SMI INC

Oct. 04.2017

MATERIAL CHANGE OF LEADFRAME FOR 86SMX(LPN) CRYSTAL

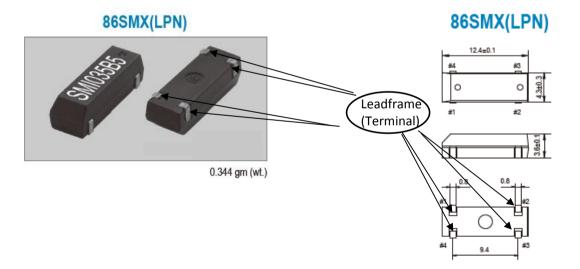
This is to inform you that the material of leadframe for 86SMX(LPN) will change to Brass from 42 alloy. The plating materials will remain the same.

Item	Current	New
Material	42 alloy (42%Ni-Fe)	Brass (C2680R01/2H)
Plating(under)	Nickel	Nickel
Plating(surface)	Tin	Tin

The material change will be effective immediately after the current 42 alloy stock leadframes will be depleted and will be expected in January 2018
